Docket No. 50-244
LS05-81-05-002

By letter dated March 26, 1981, we issued Amendment No. 38 to Provisional Operating License No. DPR-18 for the R. E. Ginna Nuclear Power Plant. Amendment No. 38 approved technical specifications related to degraded grid voltage protection for the Class 1E power system.

Accordingly, we are enclosing corrected Technical Specification pages 2.3-4, 2.3-5, 2.3-8, 2.3-10, 3.5-4a and 4.1-7, which are to replace the pages issued by Amendment 38.

FIG. 2.3-1

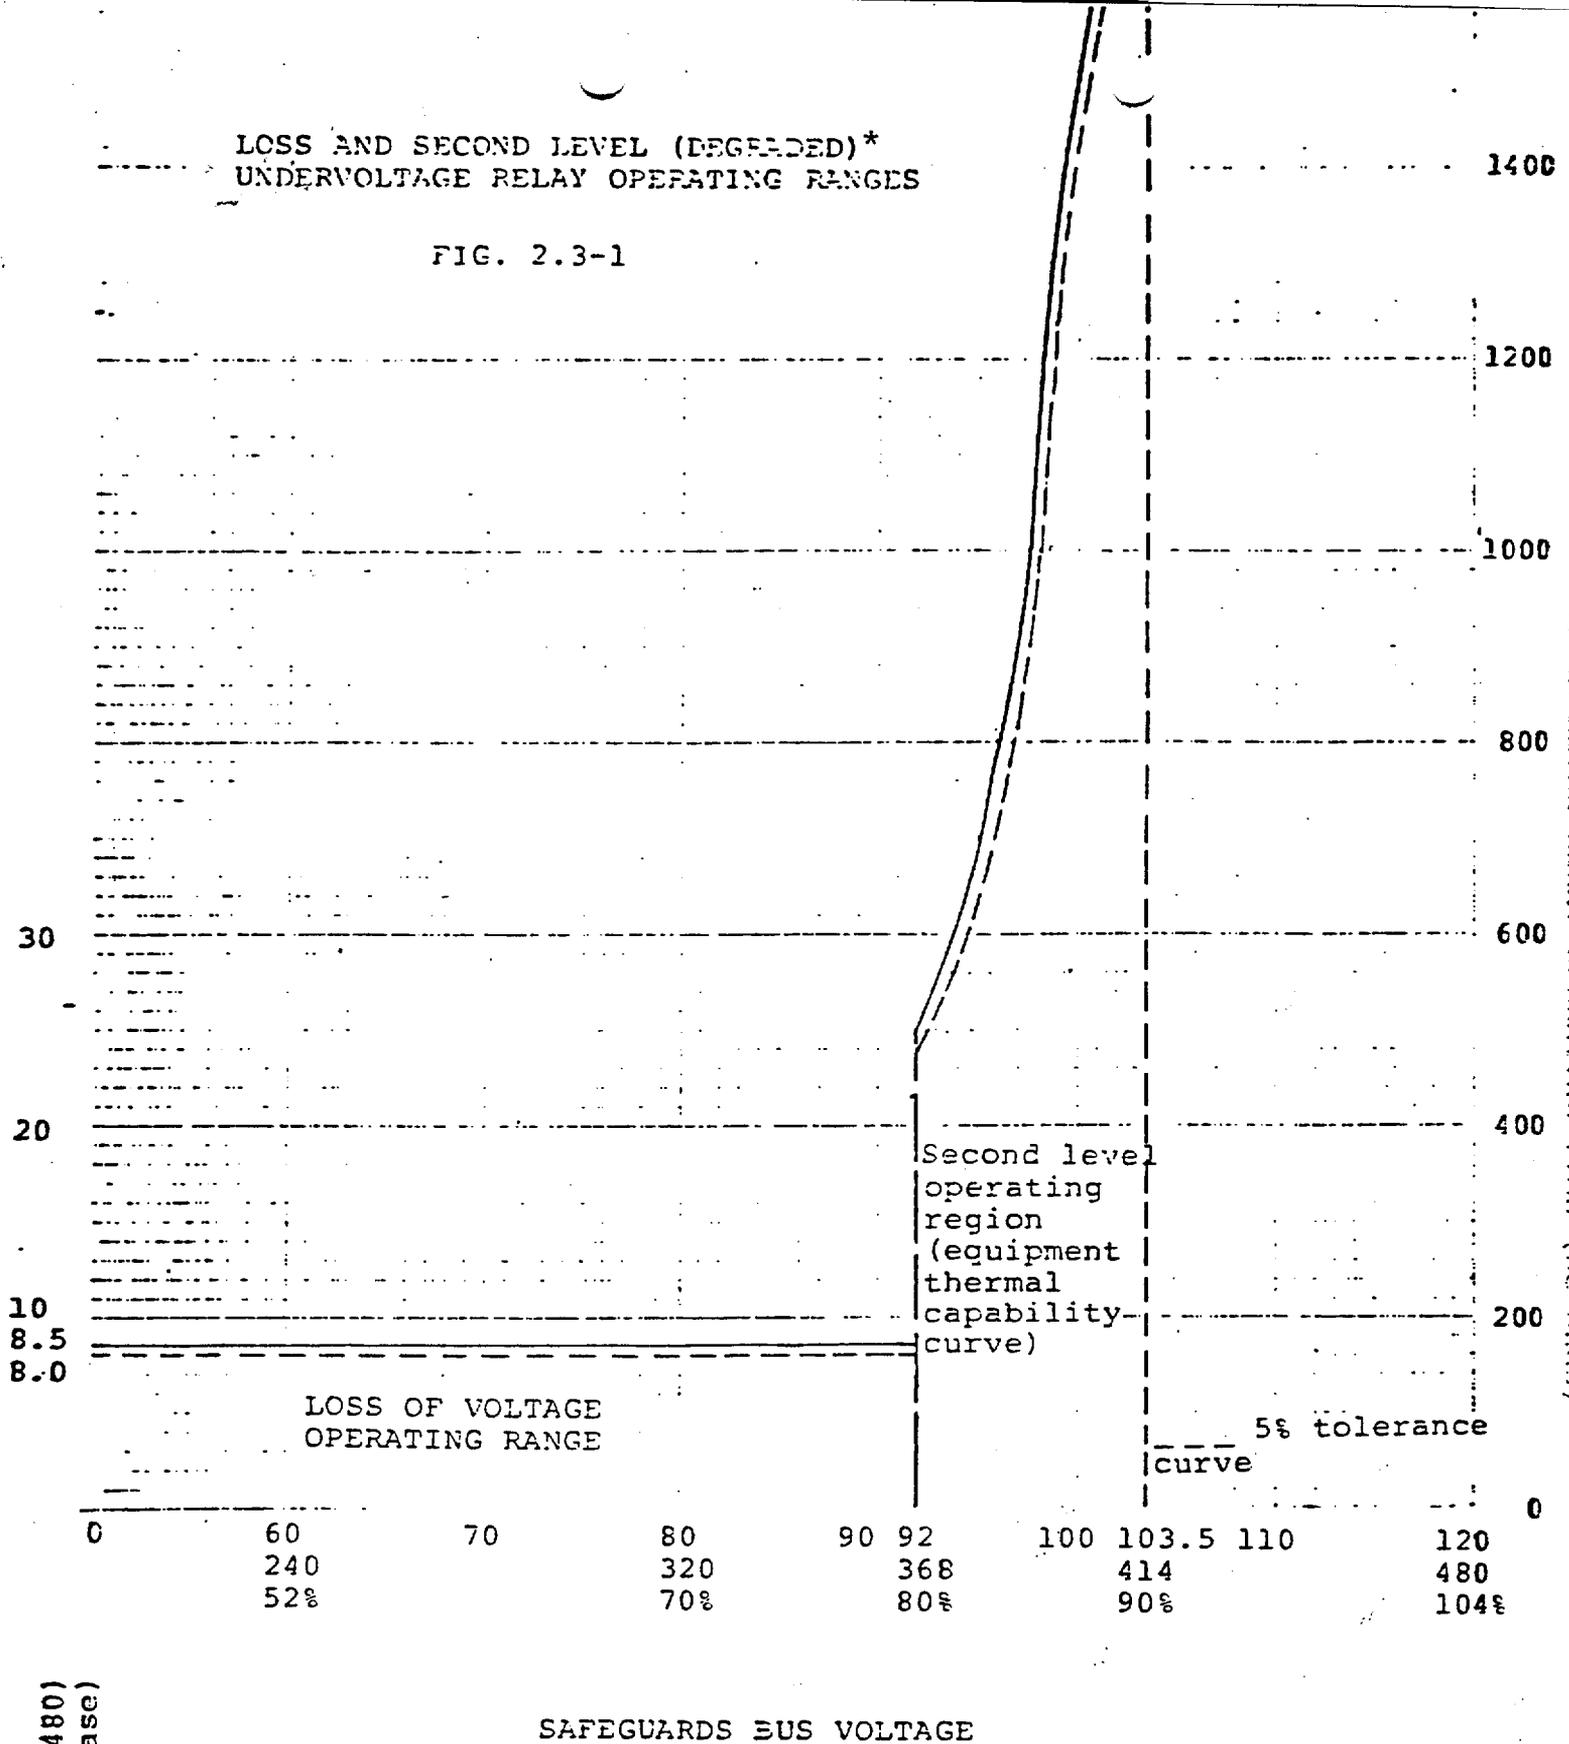
*Effective 30 days after completion
 of necessary modifications and
 no later than completion of the
 Spring 1982 refueling outage

2.3.3.2* Acceptable degraded voltage relay operating times and setpoints, for 480 volt safeguards bus voltages \leq 414 volts and $>$ 368 volts are defined by the safeguard equipment thermal capability curve shown in Figure 2.3-1. Measured values shall fall at least 5% below the theoretical limit. This 5% margin is shown as the 5% tolerance curve in Figure 2.3-1.

The 5% tolerance curve in Figure 2.3-1 and the requirements of specifications 2.3.3.1 and 2.3.3.2 include 5% allowance for measurement error. Thus, providing the measurement error is less than 5%, measured values may be directly compared to the curve. If measurement error exceeds 5%, appropriate allowance shall be made.
